**REMARKS**

This amendment after Final is in response to a Final Office action (Paper No. 8) mailed March 25, 2003. Upon entry of this amendment, claims 1-5, 7 and 9-34 will be pending in this application. Applicant has amended claims 1, 5, 17, 20, 22 and 23 by this amendment and has newly added claims 24-34 by this amendment.

FIG. 2

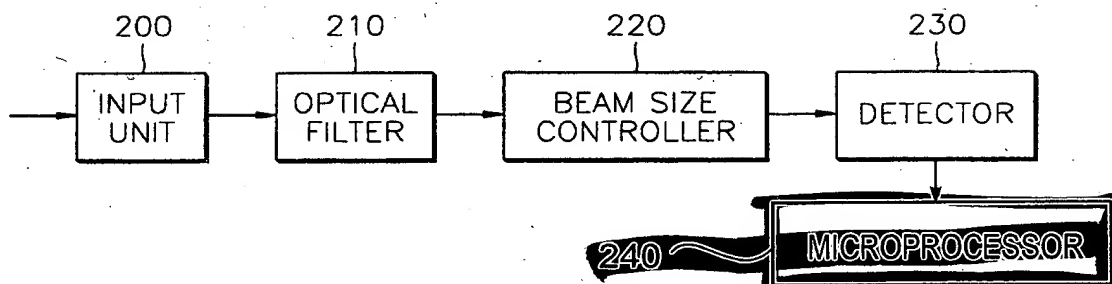
In Paper No. 8, the Examiner objected to the drawings. Applicant has amended FIGS. 2 and 3 by this amendment making these objections moot.
